## **TUTTLE ADDITION SUBDIVISION, RESUBDIVISION OF LOT 20 SQUARE 6**

***Revised for the December 3, 2015 meeting:***

APPLICATION NUMBER 3 DATE November 19, 2015  
APPLICANT Tuttle Addition Subdivision, Resubdivision of Lot 20 Square 6  
REQUEST Subdivision

## DETAIL SITE PLAN

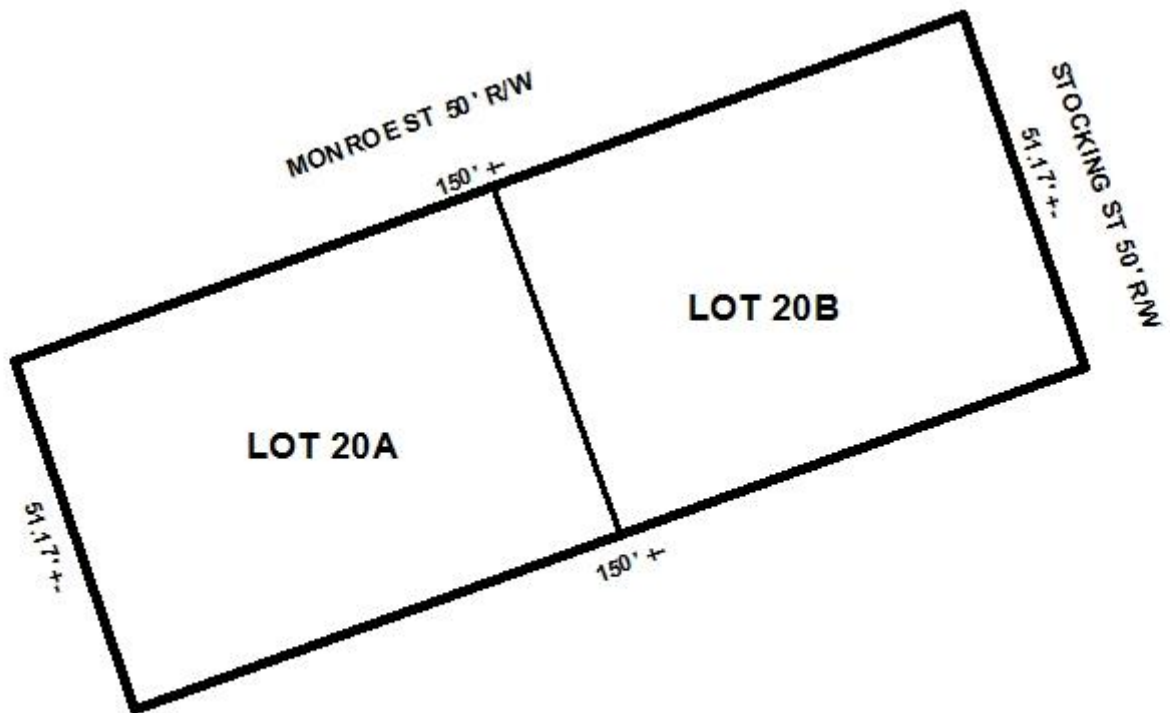
- B. Survey Data – boundary lines with length and bearings, 2' contours, existing drainage conditions and features;
- C. Show the existing building on the Preliminary Plan.

- D. Dedicate the corner radius (25' minimum or as approved by the City Engineer and Traffic Engineer) at the northeast corner of LOT 20B.
- E. Provide and label the monument set or found at each subdivision corner.

The site has frontages onto Monroe Street and Stocking Street, both minor streets with curb and gutter. Both roads are illustrated as having existing compliant 50' rights-of-way, making no dedications necessary. However, dedication of the corner radii at Monroe Street and Stocking Street per Section V.D.6. of the Subdivision Regulations should be required.

The 25-foot minimum building setback line, required in Section V.D.9., is not shown on the preliminary plat. The setback should be illustrated on the Final Plat, if approved.

The proposed lot sizes are provided in square feet, and would not meet the minimum required lot size of 7,200 square feet in Section V.D.2. of the Subdivision Regulations. Despite the fact that the site is in an older part of the City of Mobile, and there are several sub-standard lots in the area, around 6,300 square feet at the smallest, the proposed subdivision would result in lots that would be 3,948 and 3,726 square feet each, which is substantially smaller than any other lots in the vicinity. The applicant did not provide any justification for the creation of these two sub-standard lots.

- 1) the proposed lots do not meet the minimum size requirement of Section V.D.2. of the Subdivision Regulations.

*Since the site is within the Leinkauf Historic District, it is recommended that the standard 25-foot minimum building setback required by Section V.D.9. of the Subdivision Regulations be waived, to allow for the application of setbacks allowed by the Zoning Ordinance, more specifically, the Historic District Overlay.*

*Also, the corner radius requirement of Section V.D.6. of the Subdivision Regulations, since it may impact the existing building, should be made subject to a determination by the City Engineer of the need for the radius.*

- 1) Placement of a note on the Final Plat stating that each lot is limited to one curb-cut, with the size, design and location to be approved by Traffic Engineering, and to comply with AASHTO standards;

- 2) Placement of a note on the Final Plat stating that all setbacks shall be per the requirements of the Zoning Ordinance;
- 3) Provision of a corner radius in compliance with Section V.D.6. of the Subdivision Regulations, if determined necessary by the City Engineer;
